# **MORRISTOWN REGIONAL PLANNING COMMISSION**

TO: Morristown Planning Commission  
FROM: Lori Matthews, Senior Planner  
DATE: November 10th 2020  
SUBJECT: Grovewood Subdivision - Preliminary Plat Approval and Variance Requested

**Plan Case Number:** MASD-002442-2020

TO: Morristown Planning Commission  
FROM: Lori Matthews, Senior Planner  
DATE: November 10th 2020  
SUBJECT: MUD Concept Plan Request

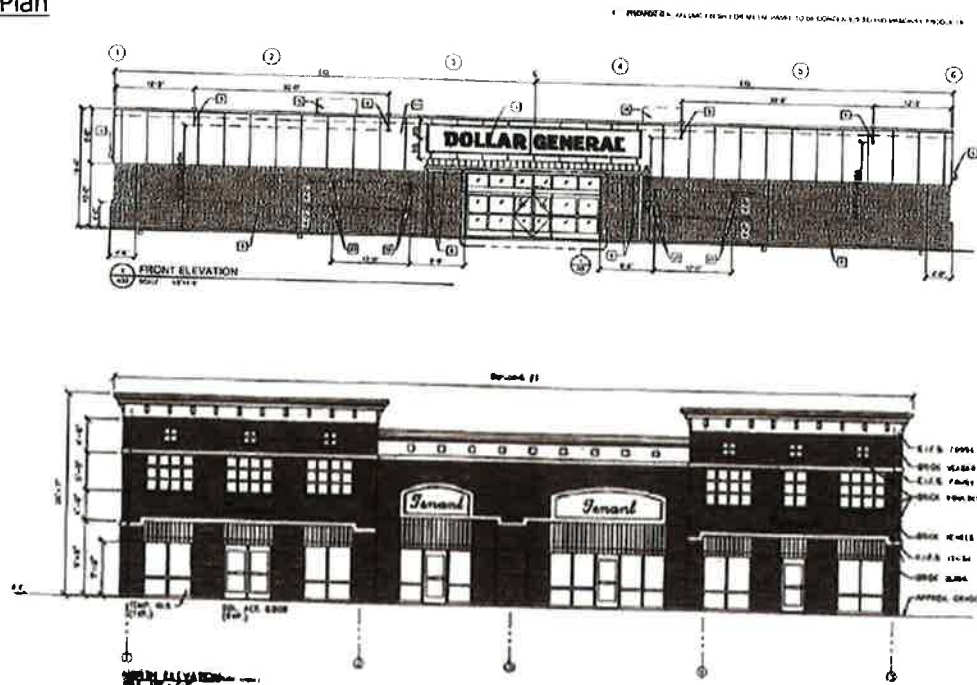
For the 20+/- acre portion to be residentially developed, the only concern Staff has is compliance with the 30% required open space and the 28 foot pavement requirement. Not much has changed between the old and newer plan except for the number of proposed housing units. Staff feels confident this is very much similar to the original plan.

OVERALL  
SITE PLAN

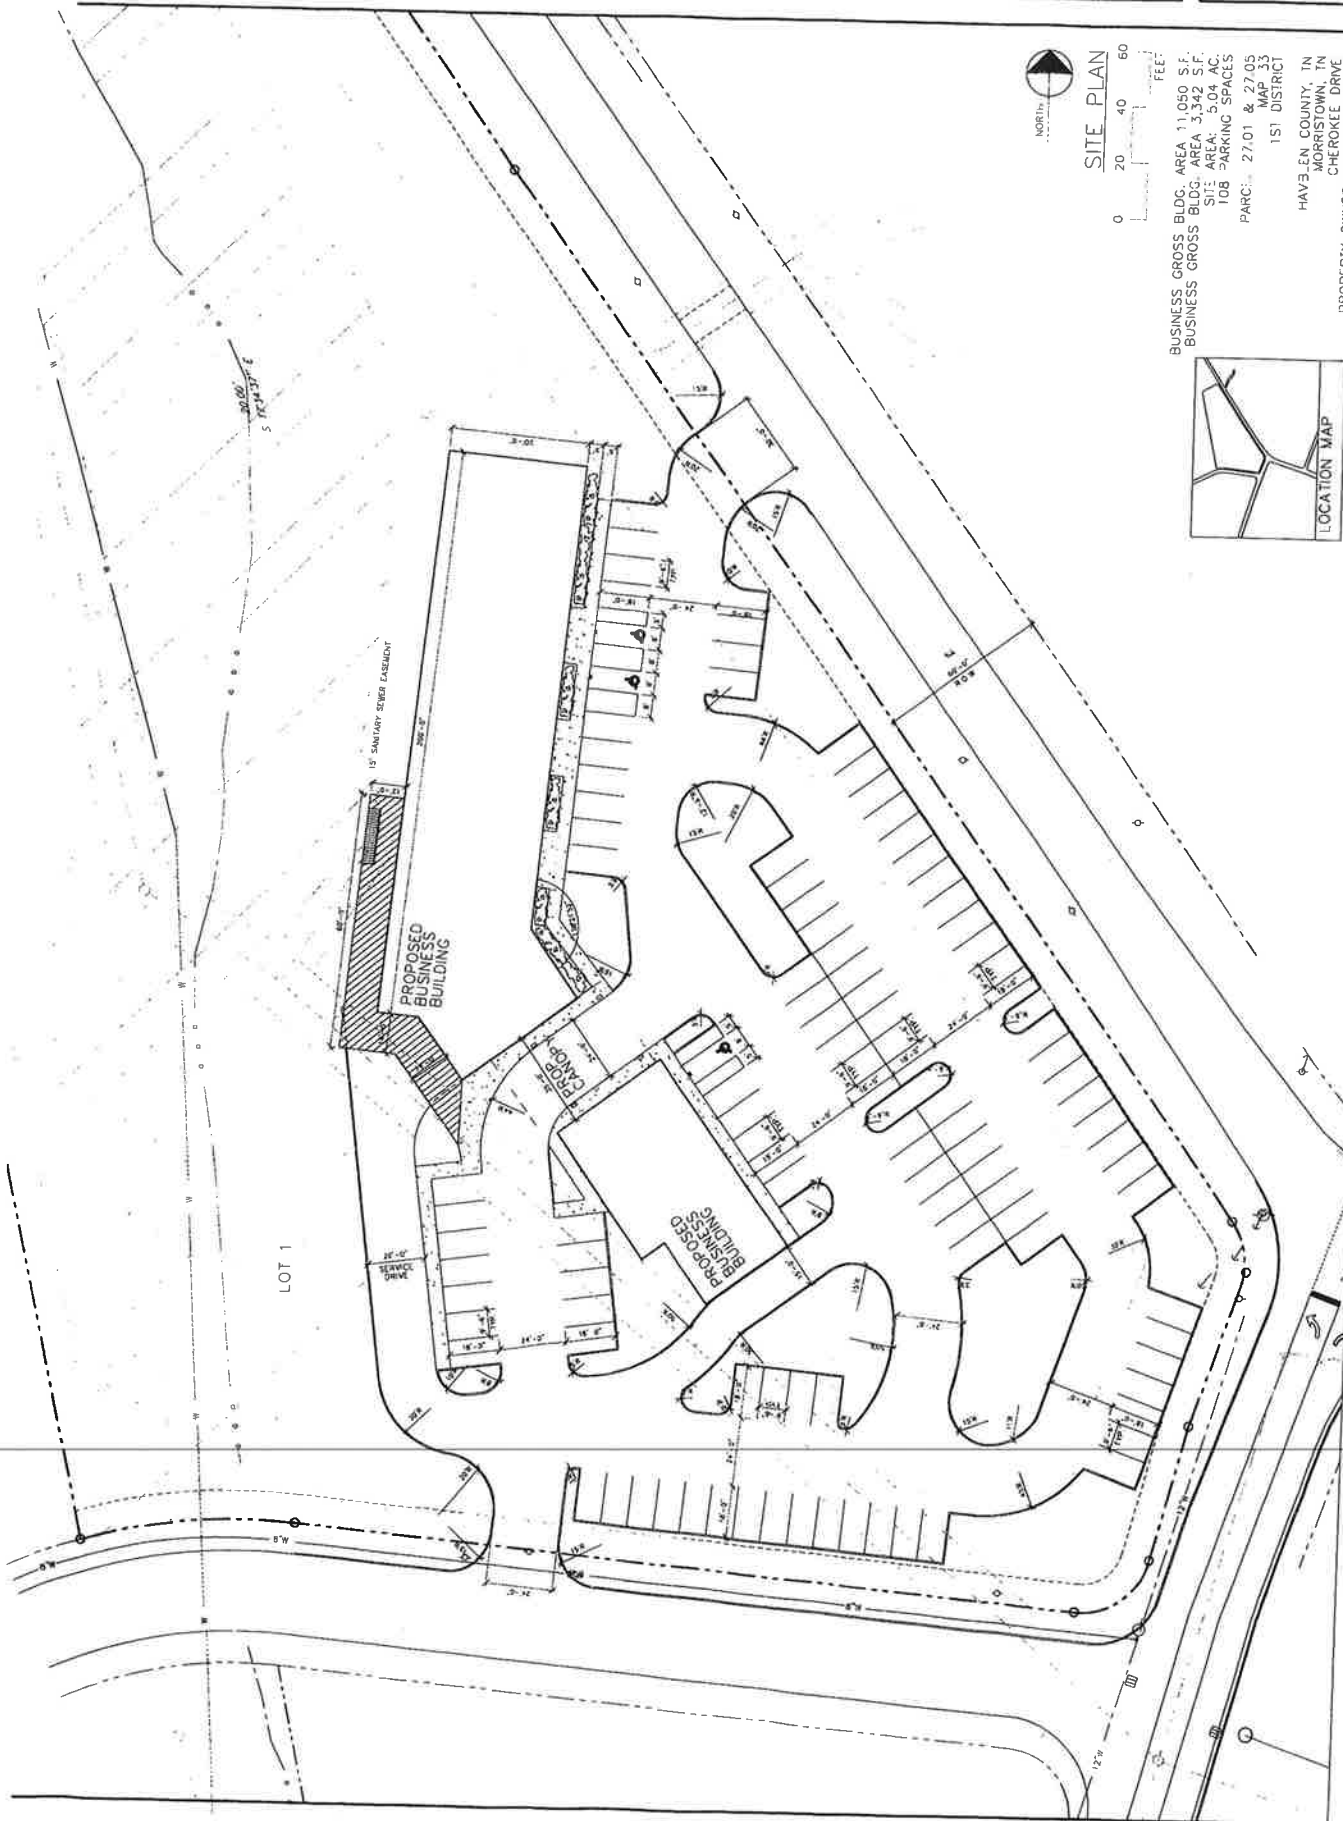
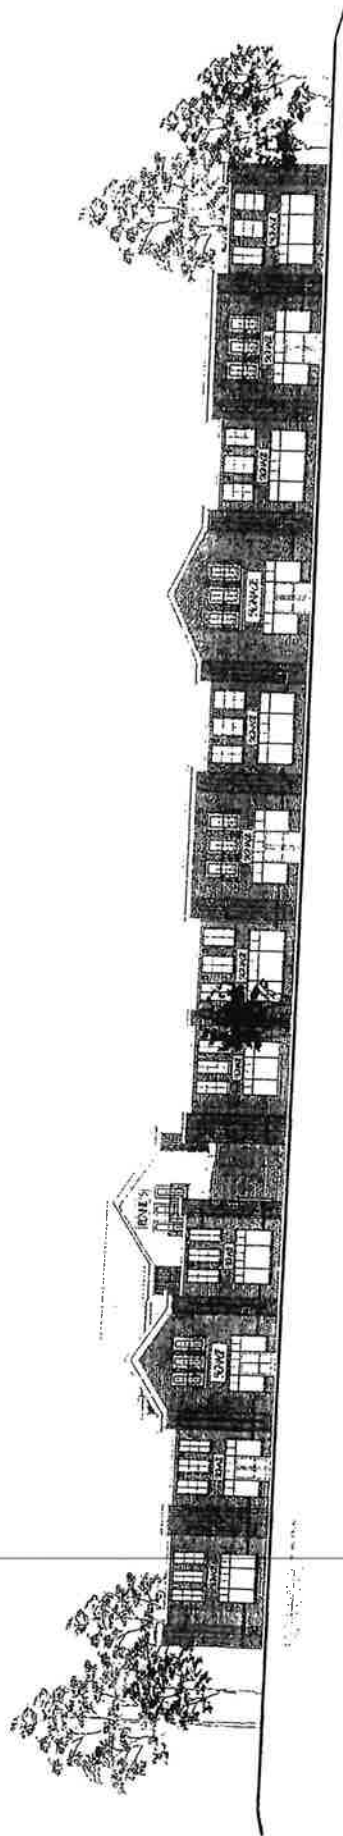
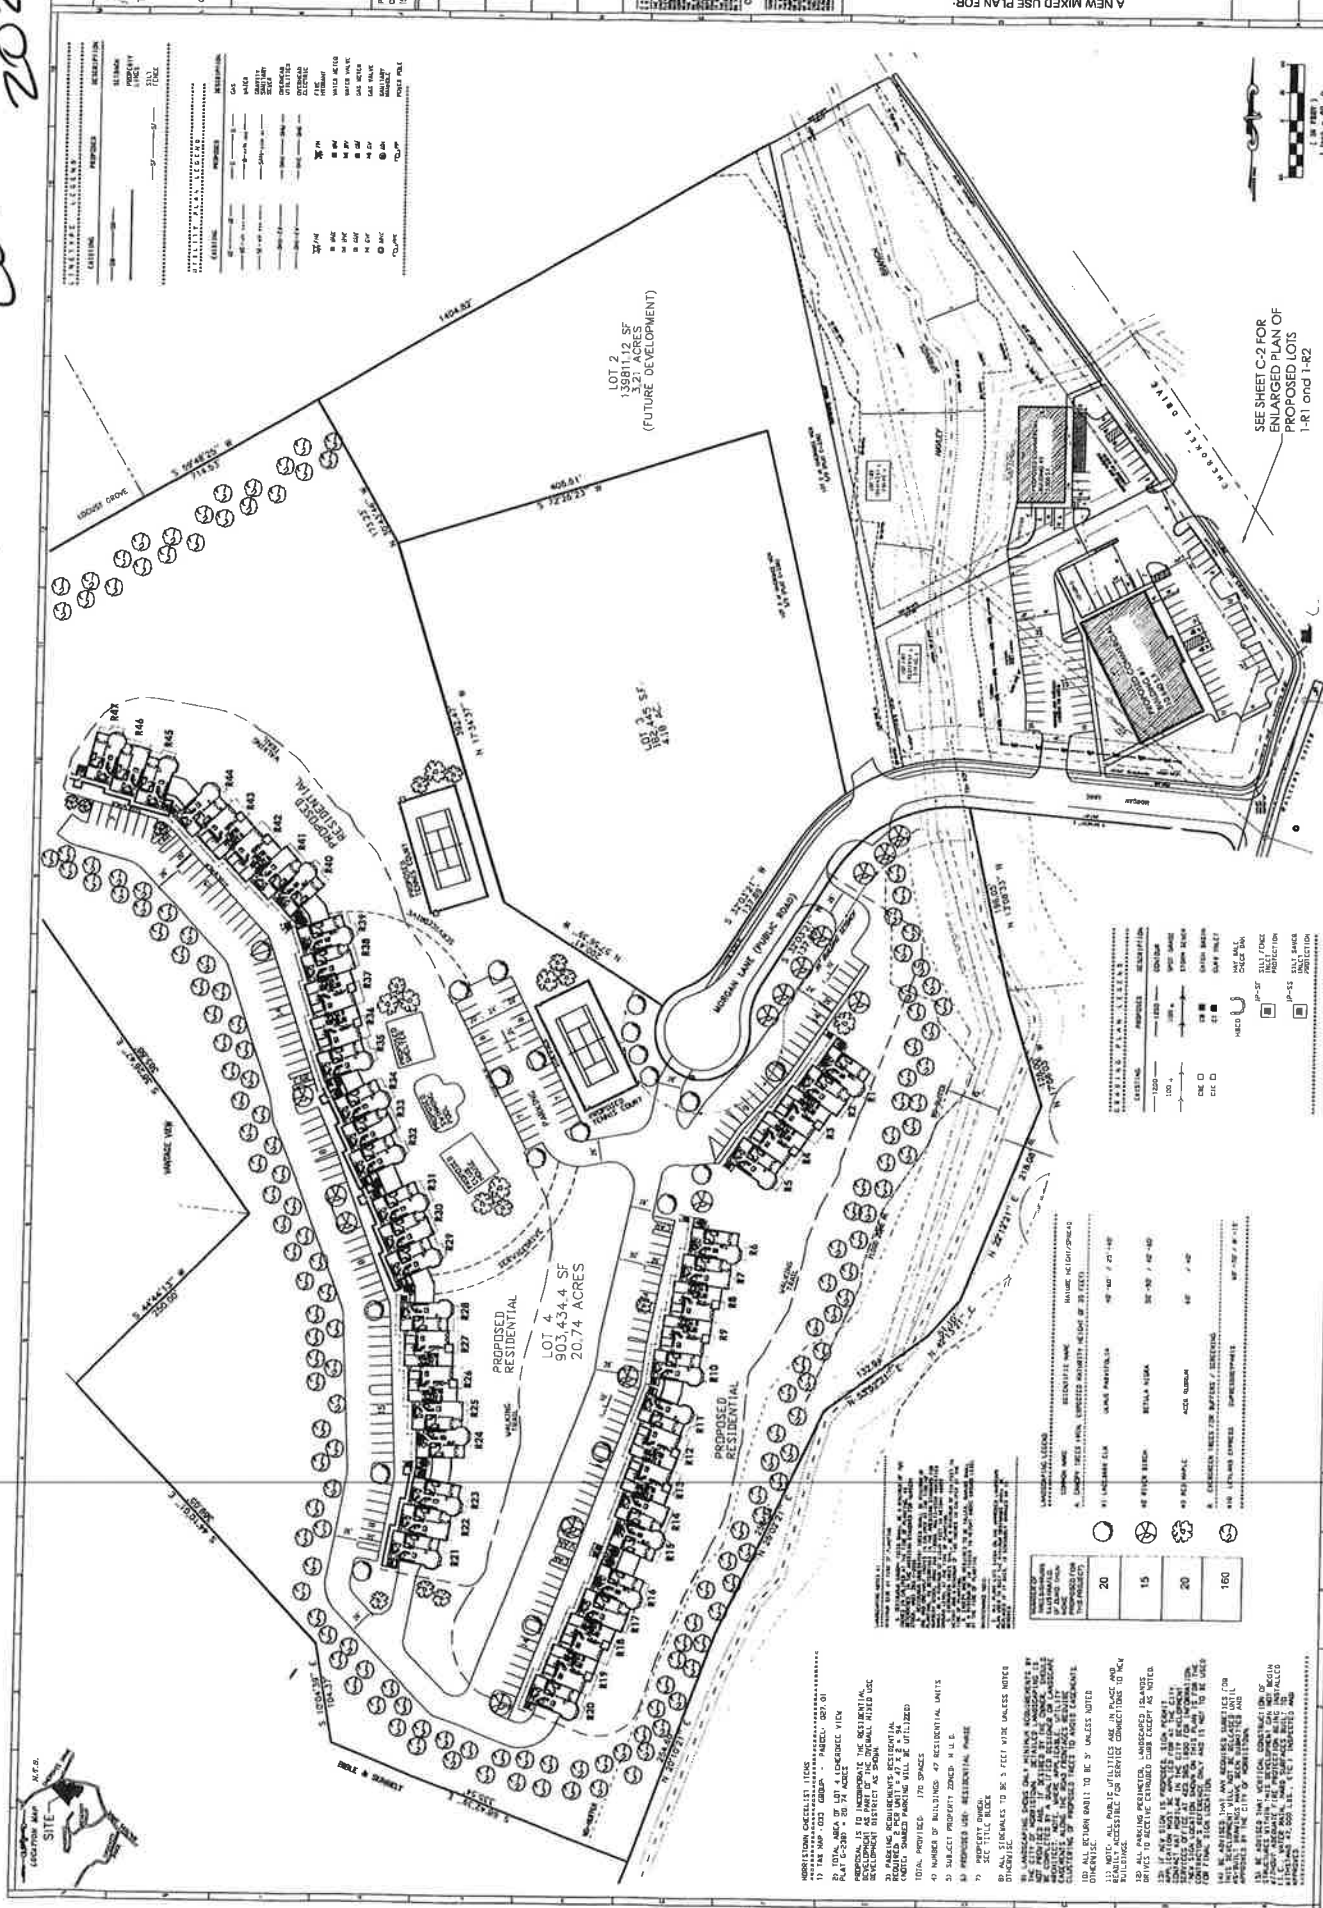
The commercial portion of the plan has significantly changed in both configuration and elevation models. Original plans (as shown below) show a well- designed large commercial plaza on a single lot. The new plan shows one small commercial building on two separate lots. These items could be changed. Staff is concerned that only one of the retail lots will be constructed, and the remainder of the plan will not be built. The entire property would then be in violation of the Zoning Ordinance.

As stated, Staff feels the residential portion of the project is consistent with the plans approved in 2007. However, the commercial aspect of the newer plans does not seem consistent with the 2007 plan and Staff cannot support this request at this time.
